PLANNED UNIT DEVELOPMENT & SUBDIVISION STAFF REPORT

DEVELOPMENT NAME Heron Lakes Subdivision, Phase 1, Lot 80,

CONTEMPLATED USE Planned Unit Development Approval to amend a previously approved Planned Unit Development to allow reduced rear yard setbacks and increased site coverage.

SITE PLAN

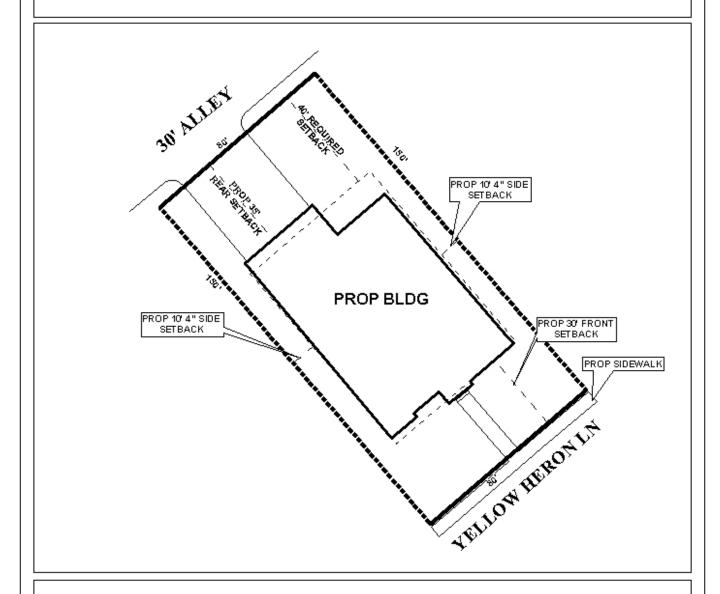
Given the number of such requests and approvals, documentation should again be provided that the existing storm water system is adequate.

Planned Unit Development Based on the preceding, the application is recommended for Approval, subject to the following conditions: 1) submission of documentation that the existing storm water facilities are adequate to handle the increased site coverage (including all previously approved increases), to be approved by City Engineering Department prior to signing of the final plat.
